# HIDEOUT, UTAH TOWN COUNCIL REGULAR MEETING

May 28, 2020

**Staff Report – Engineering Department  
Town of Hideout Planning Commission**

**Date:** April 28, 2020  
**Applicant:** Nate Brockbank  
**Subject:** Deer Springs Phase 1 Plans – Amended  
**Recommendation:** Final Approval

D:\PROJECTS\STEVE JACKSON\DEER SPRINGS - AUSTIN PROPERTY\BASE FILES\JORDANELLE PARKWAY\PP1.4 OFF-SITE WATER LINE - NORTH END AND CASINGS.DWG 4/23/2020 12:57:43 PM

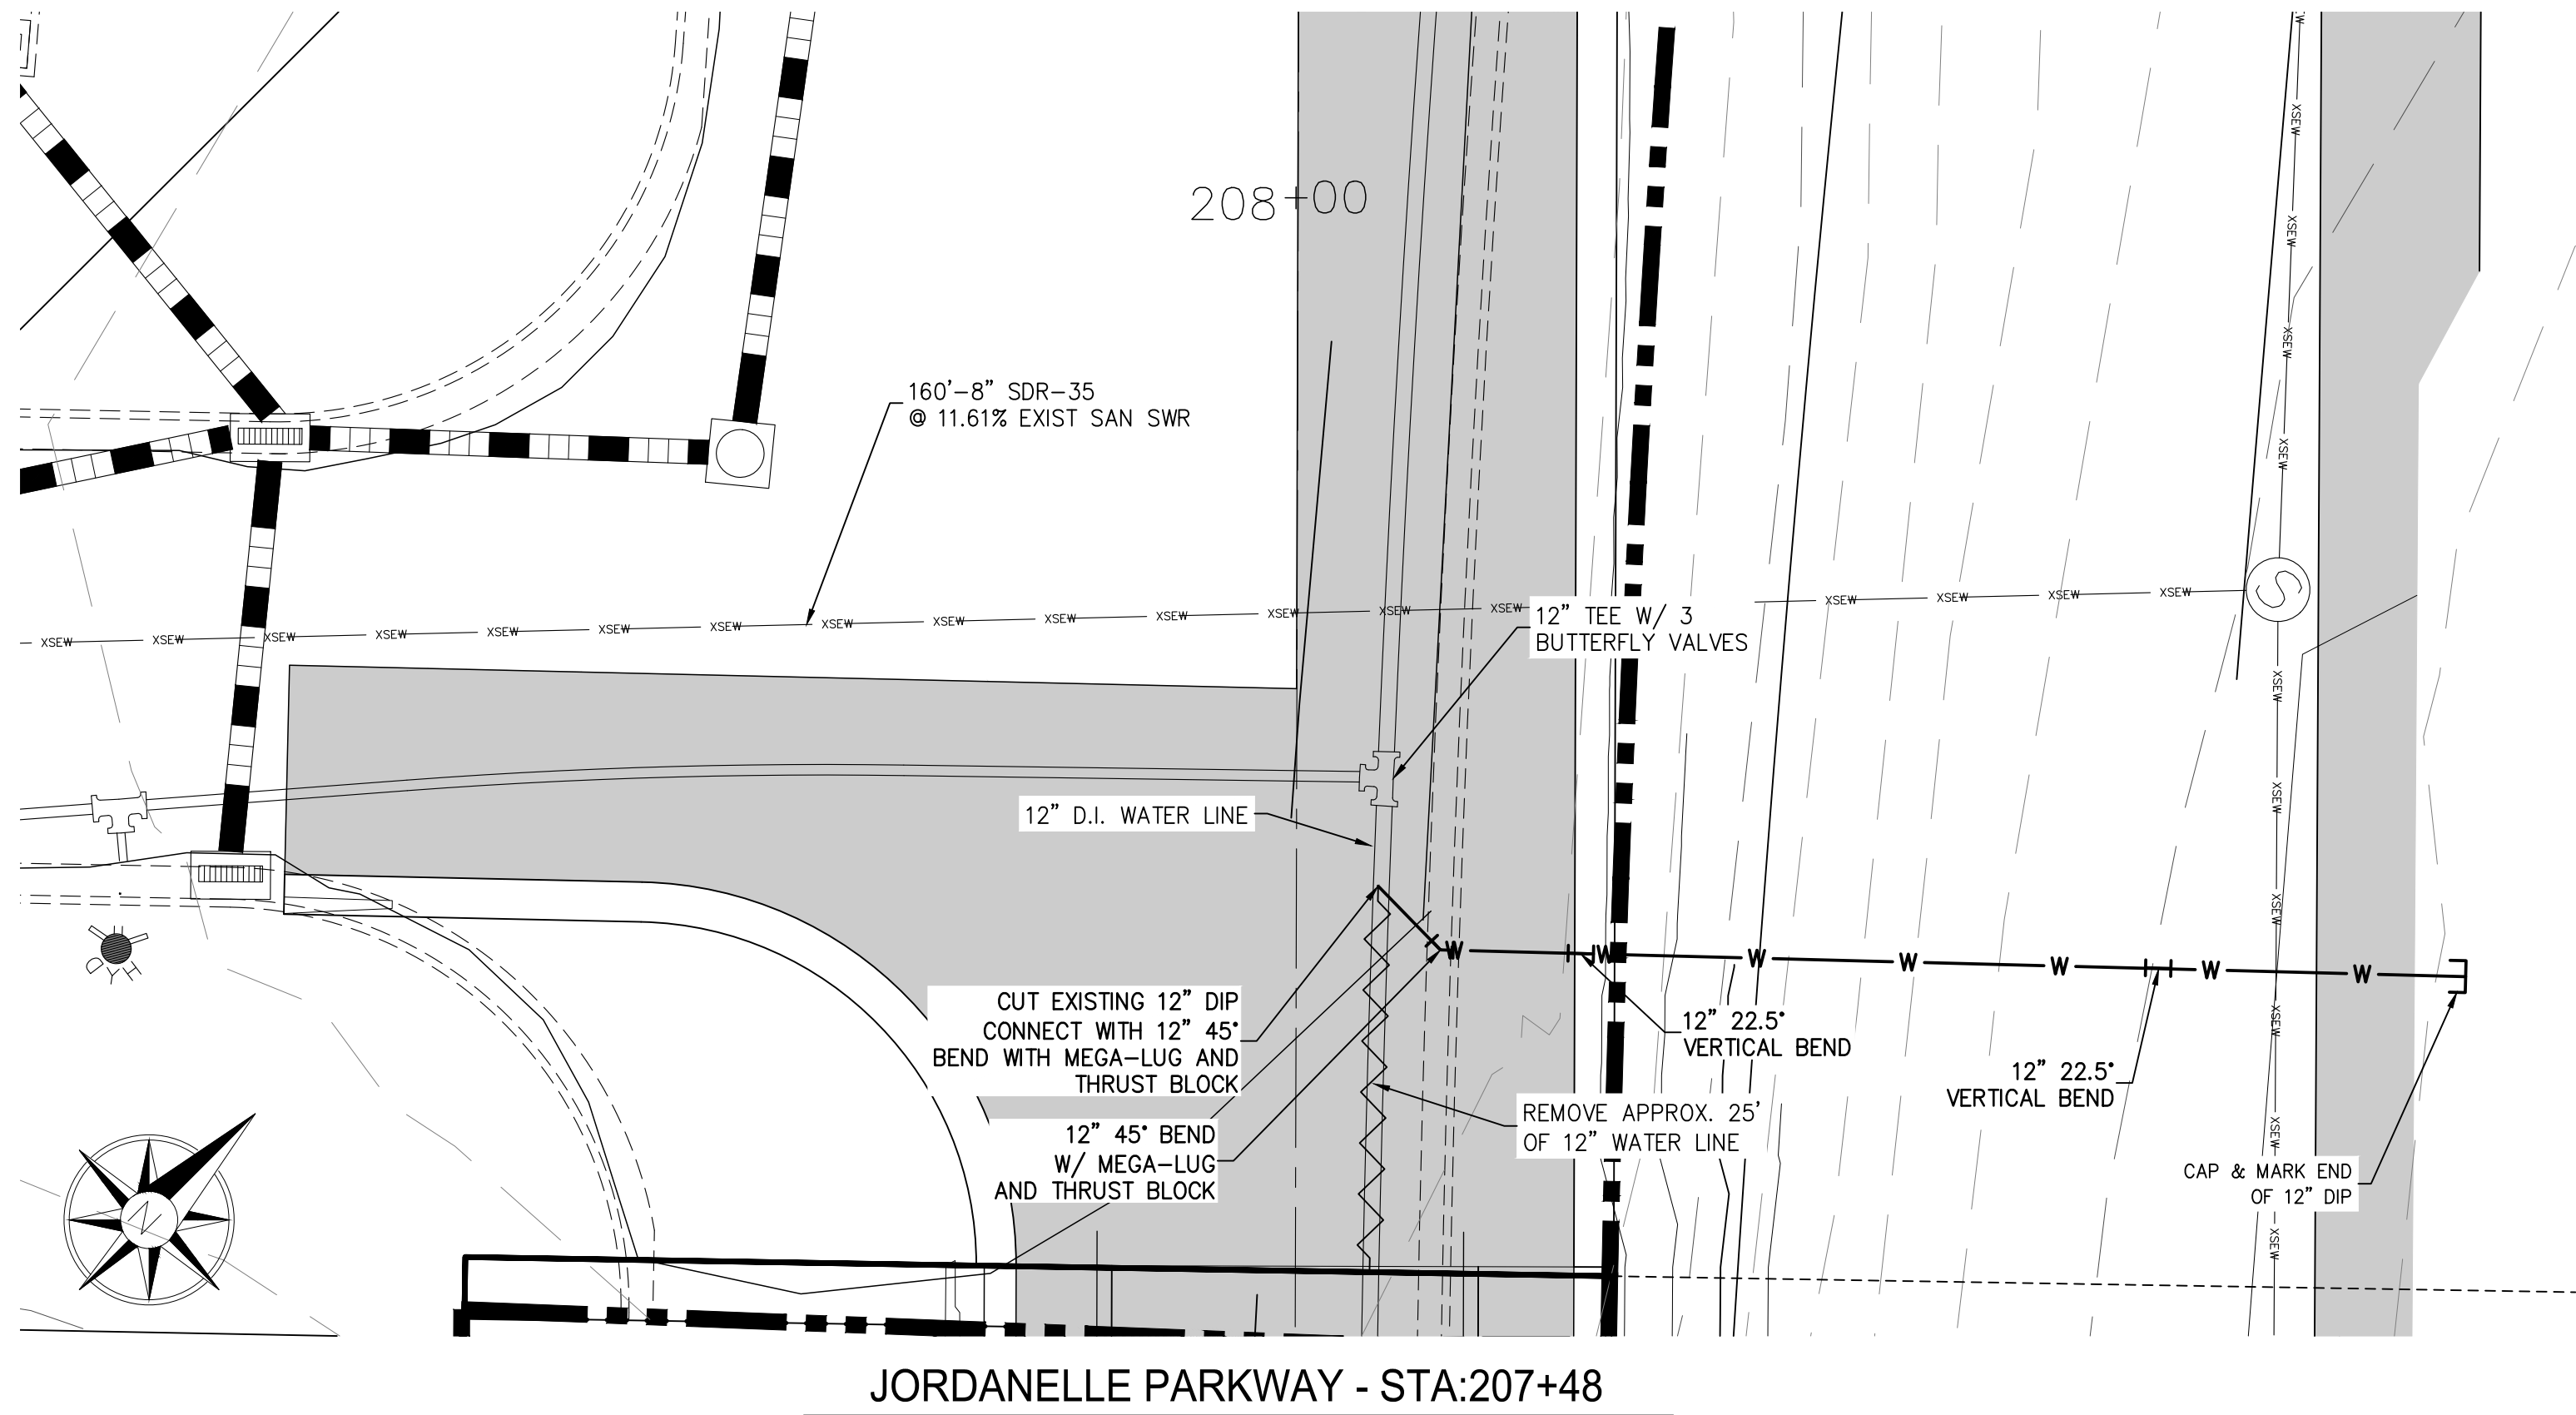
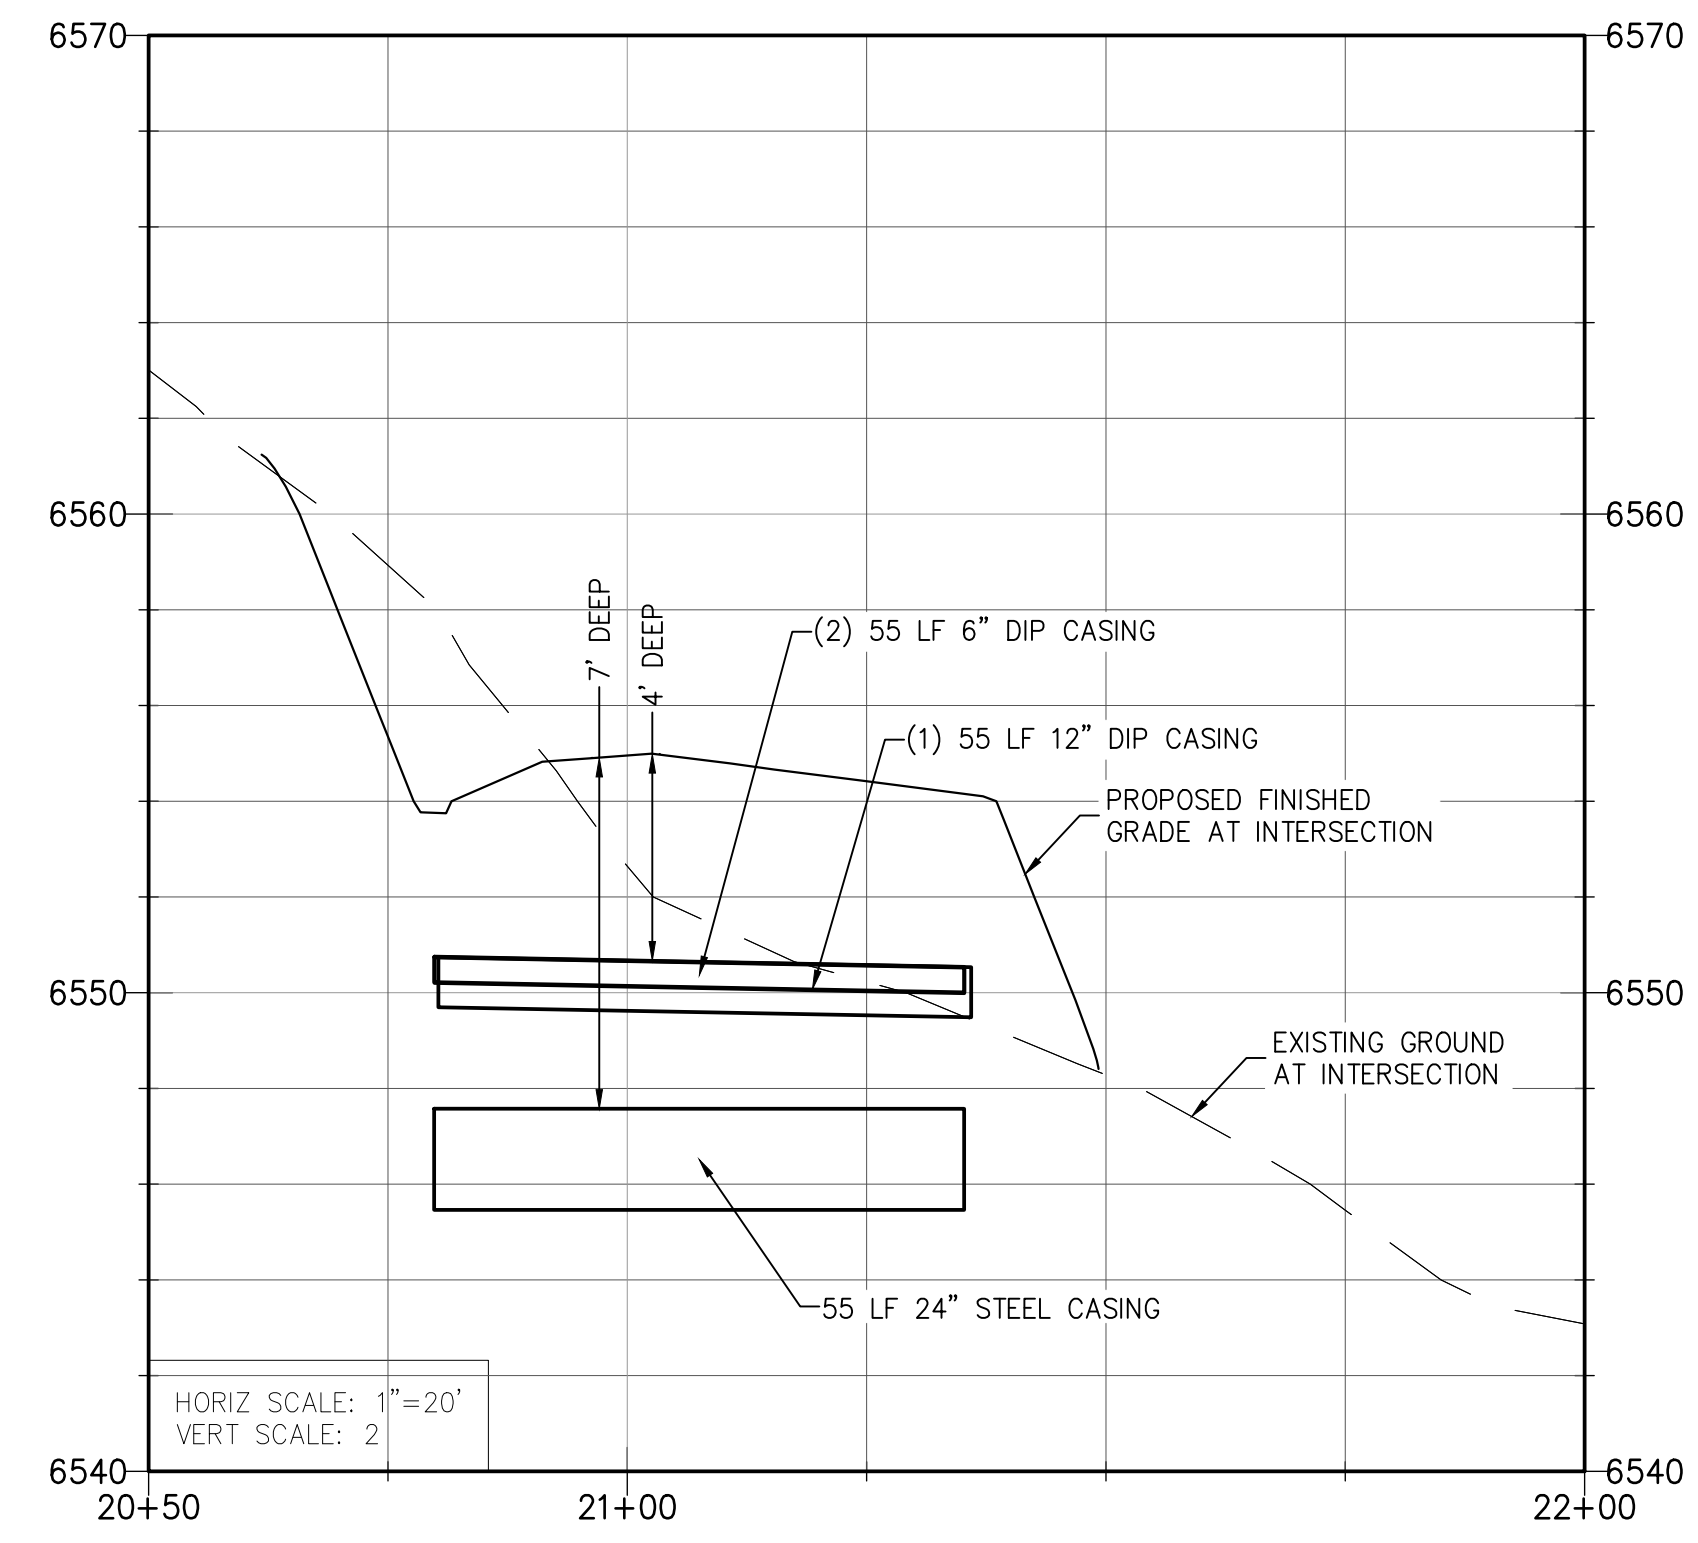
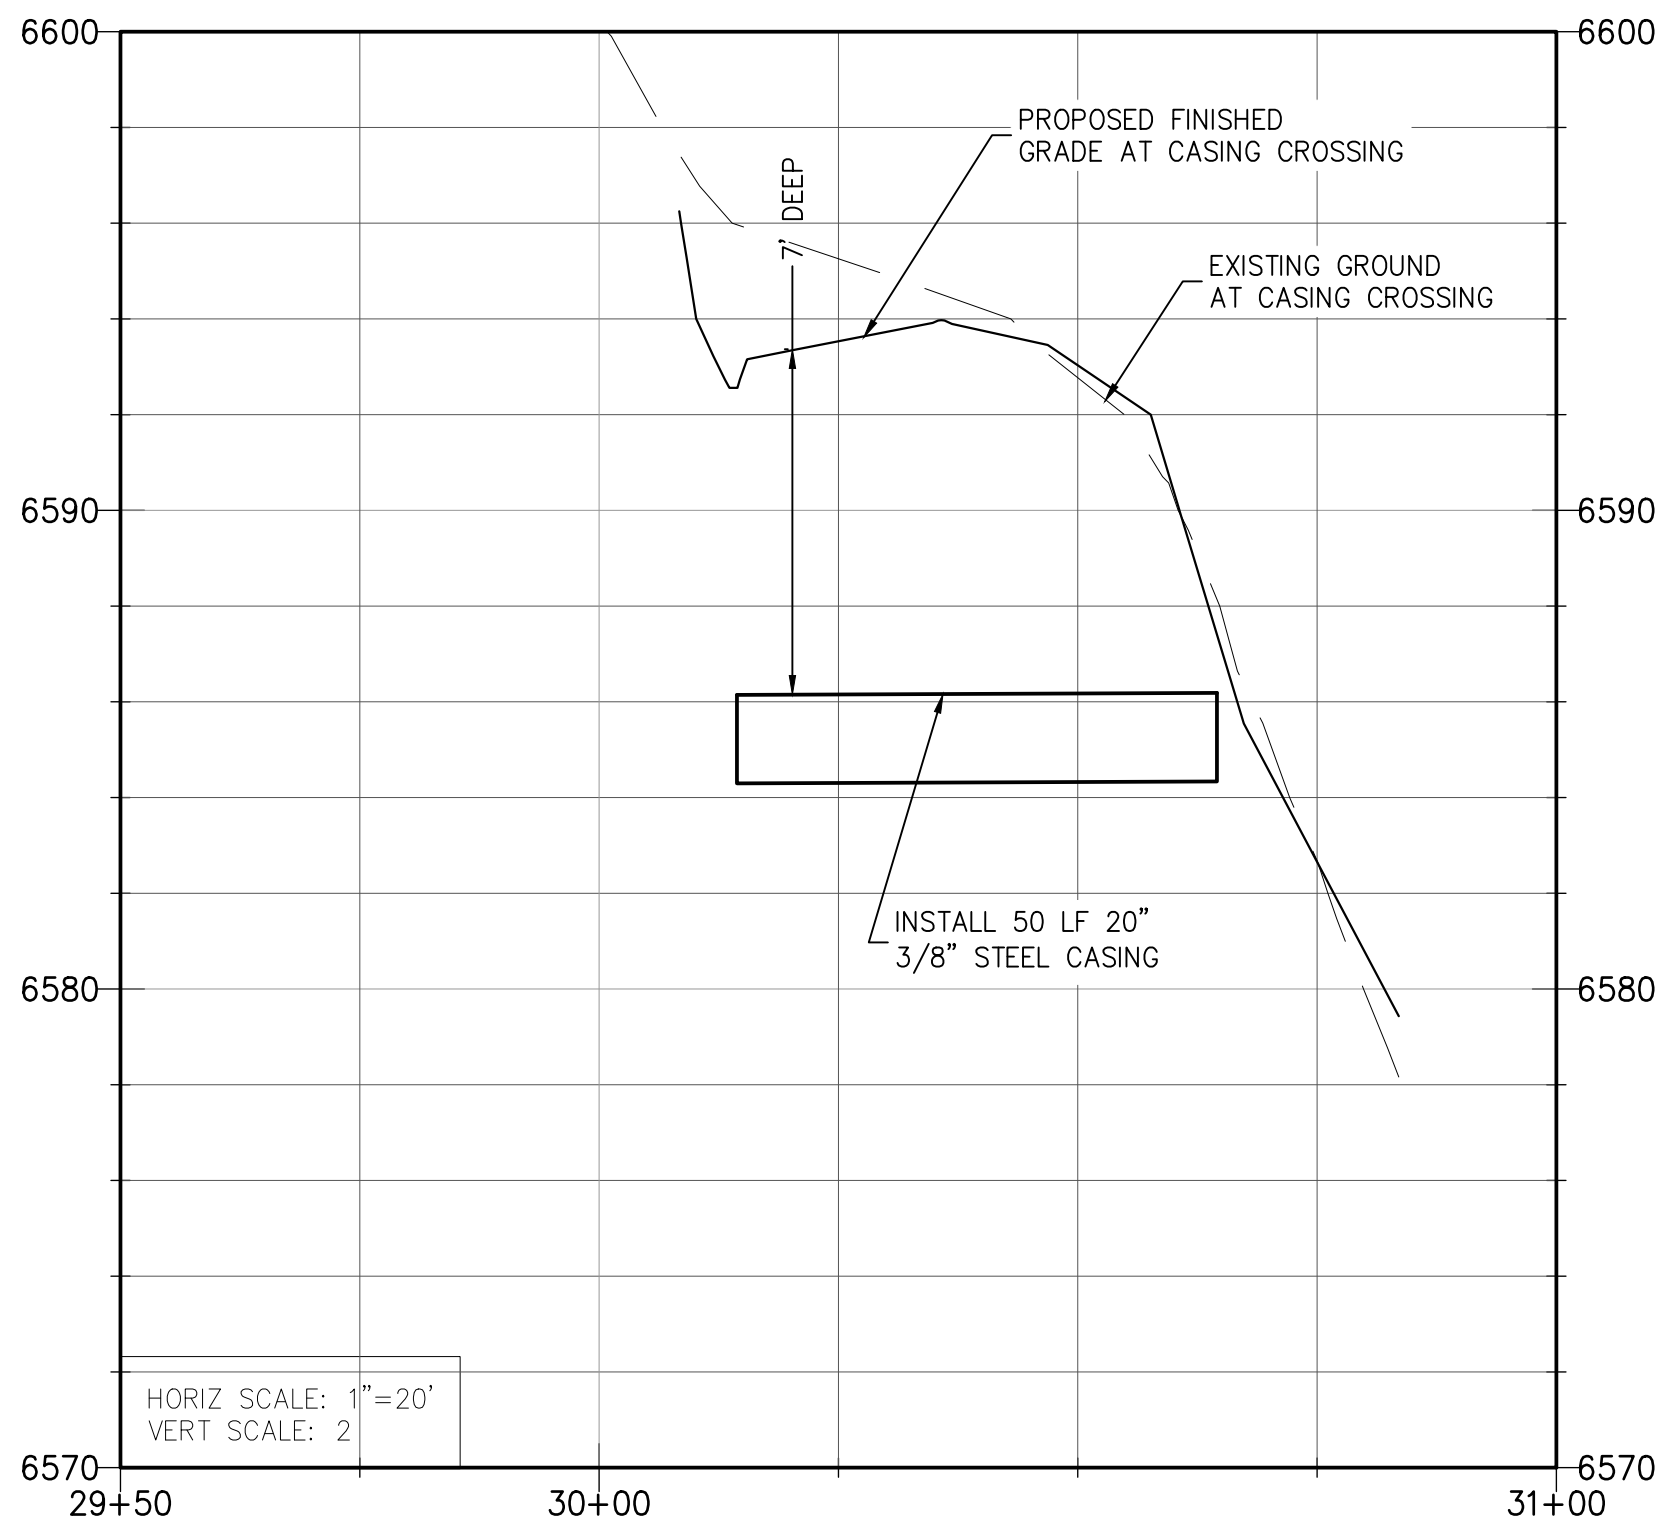
Pages PP1.4 through PP1.6 include details on placement of casings under Jordanelle Parkway for future connection. We understand that the placement of these connections and stub-out from Jordanelle Parkway is time-sensitive. However, a full plan set must be submitted and approved prior to construction of the roadway through the Deer Springs development to Jordanelle Parkway
